DIABLO CANYON INDEPENDENT SAFETY COMMITTEE

Re: Comment Letter – Once-Through Cooling Policy Special Studies.

Attachment 1
**Diablo Canyon Independent Safety Committee's Preliminary Evaluation of
Safety Issues for "Addendum to the Independent Third Party Final Technologies
Assessment for the Alternative Cooling Technologies or
Modifications to the Existing Once-Through Cooling System for
the Diablo Canyon Power Plant"**

Attachment 2
**Diablo Canyon Independent Safety Committee's Evaluation of
Safety Issues for "Independent Third Party Final Technologies Assessment for
the Alternative Cooling Technologies or
Modifications to the Existing Once-Through Cooling System for
the Diablo Canyon Power Plant"**

Fig. 1: Bechtel arrangement for a 44-cell southern cooling tower system.

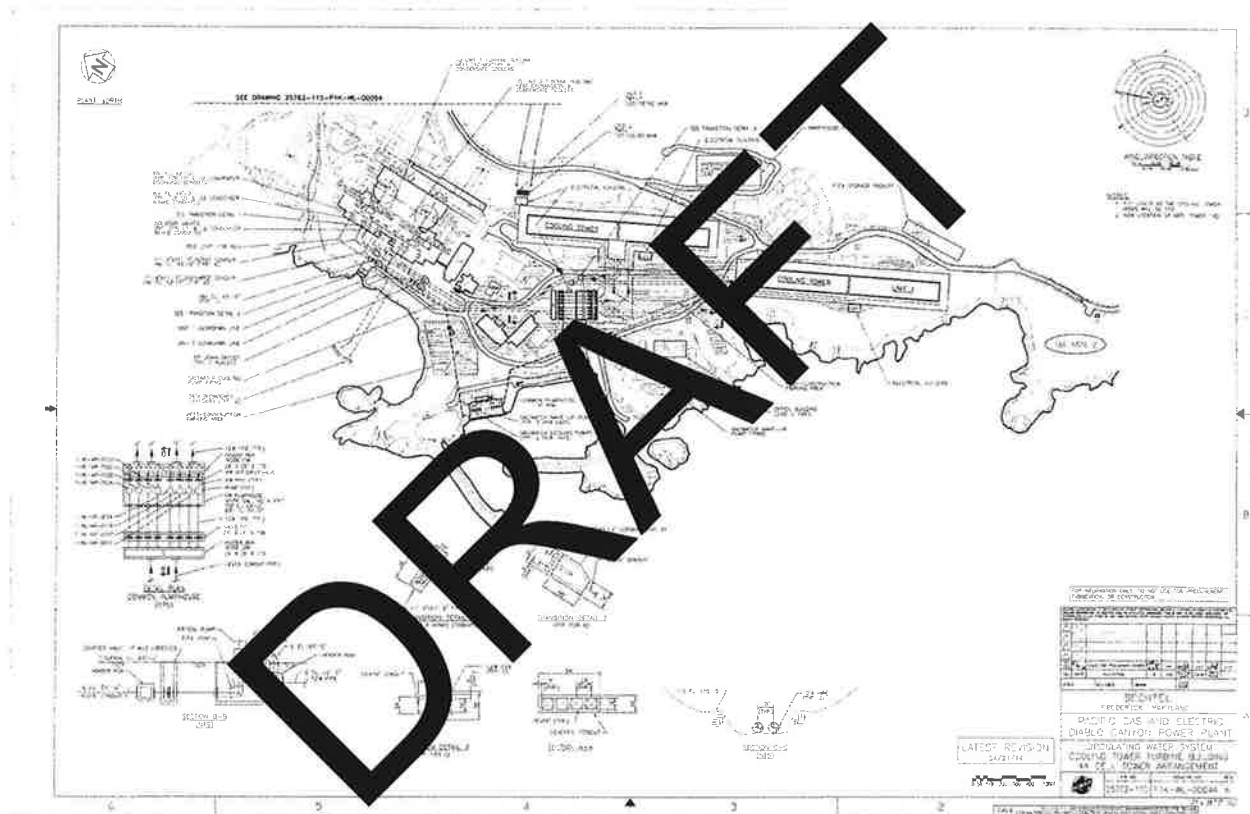
Because the primary access to the plant site is from the south and most of the plant support infrastructure, including parking, security, training, and support buildings are on the south side of the plant, southern siting of cooling towers has the potential to generate more negative impacts on plant operations, emergency response, and safety related systems than northern siting, not only during construction, but also during long-term operation.

DCISC Conclusion 1: The logistics for maintaining effective plant access for normal operations and emergency response, as well as meeting requirements for physical security during the six-year cooling tower construction period prior to the dual-unit outage, will be substantially more complex for the southern siting option.

DCISC Recommendation 1: An evaluation should be performed to understand the impact of southern-sited cooling towers on plant security and emergency response capabilities.

Fig. 2: Wind direction table for the DCPD site in 2013.

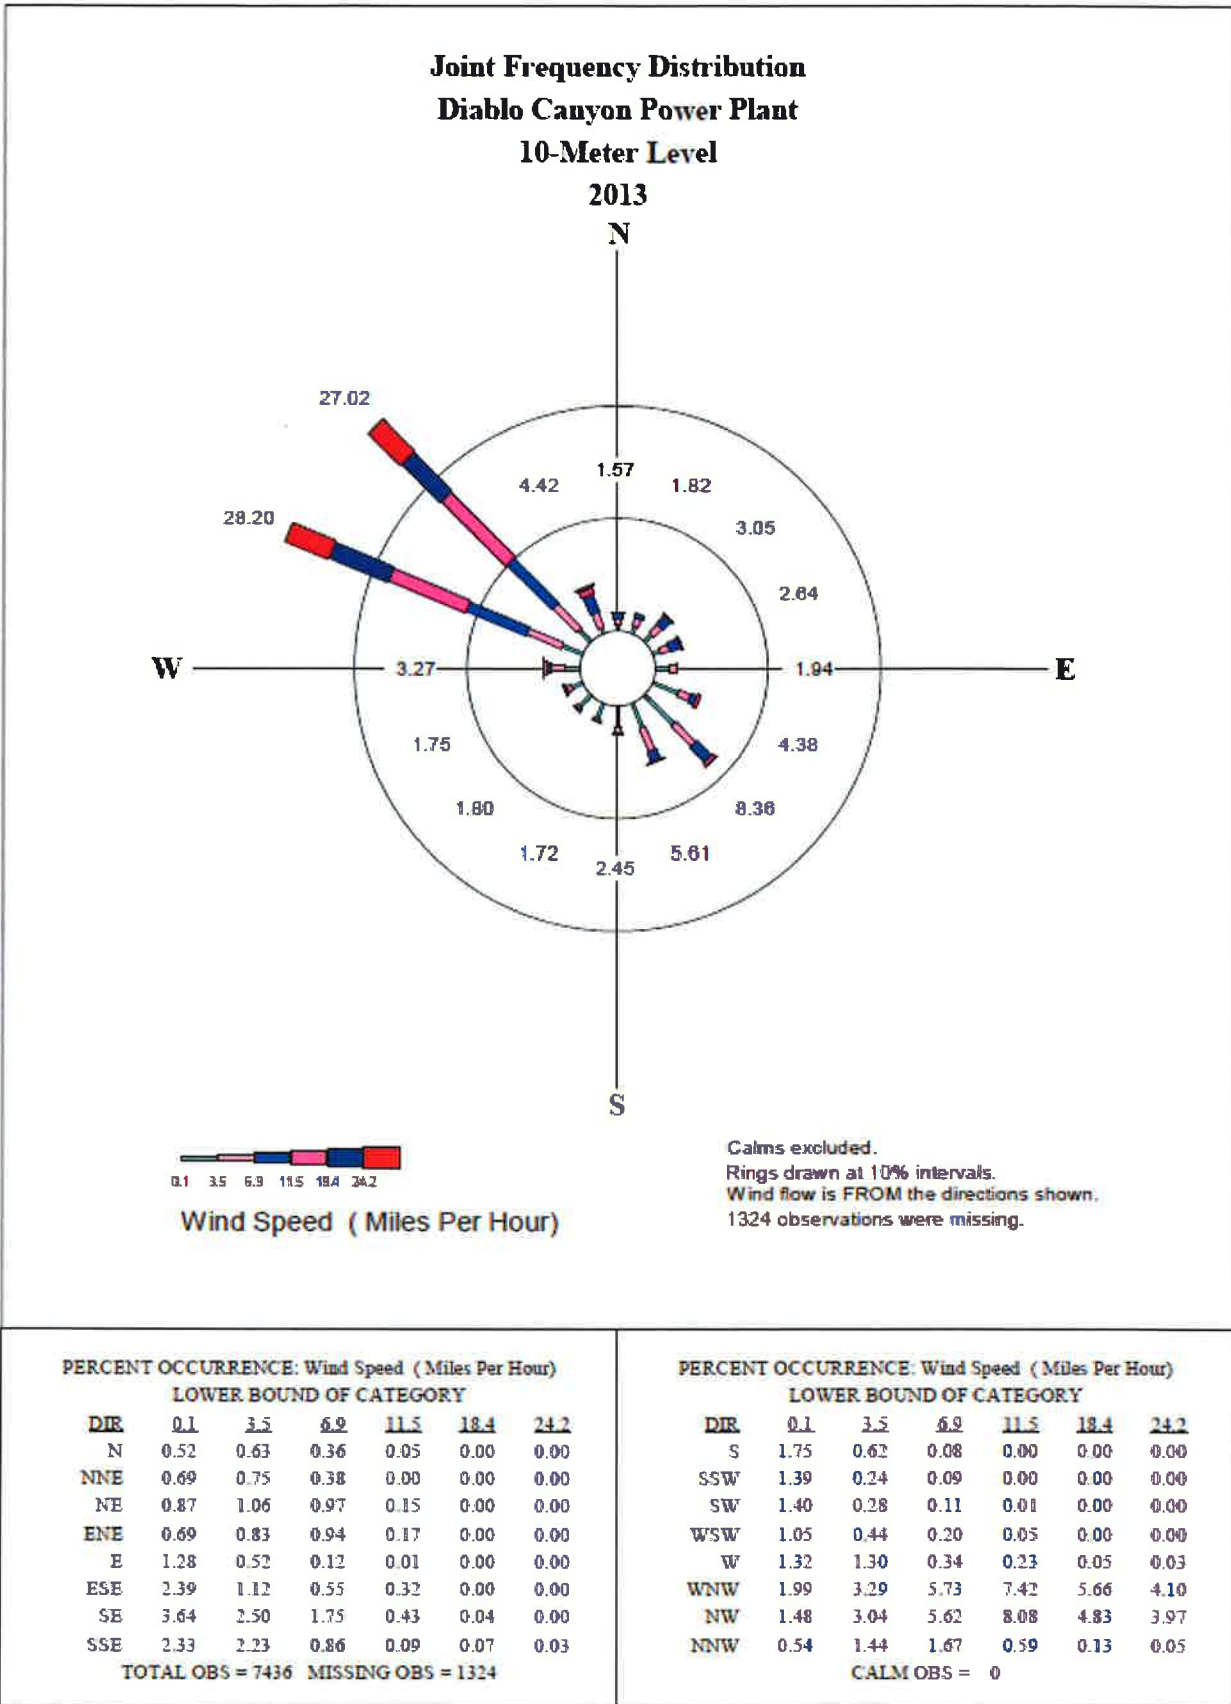
***DCISC Conclusion 5:** The use of salt water cooling towers could result in an increase in the rate of deposition of salt on DCPD plant equipment during the 10.1% of the year that wind blows from the east-south-east and the 23.3% of the year when wind speeds are very low, compared to the rate currently experienced. Higher salt deposition rates have the potential to create negative impacts on some safety-related systems, in particular Emergency Diesel Generators, and ventilation systems for the Auxiliary Building, Control Room, and Fuel Handling Building. Higher salt deposition rates may also reduce the reliability of outdoor high voltage systems that play a major role in plant safety, and increase the frequency of loss of off-site power (LOOP) events. These higher salt deposition rates could also produce negative impacts on the long-term safety of the spent fuel casks in the ISFSI, although these effects should be much less because of the longer distance from the ocean to the ISFSI.*

DCISC Recommendation 4: Simulation of rates of salt deposition from salt-water cooling towers, using available modeling tools, should be performed to assess the increase in salt deposition rates that would occur if salt water, rather than fresh water, were used in cooling towers at the site, and these simulations should be used to assess potential impacts on plant safety systems and plant reliability, to inform the decision on whether fresh water or salt water should be used.
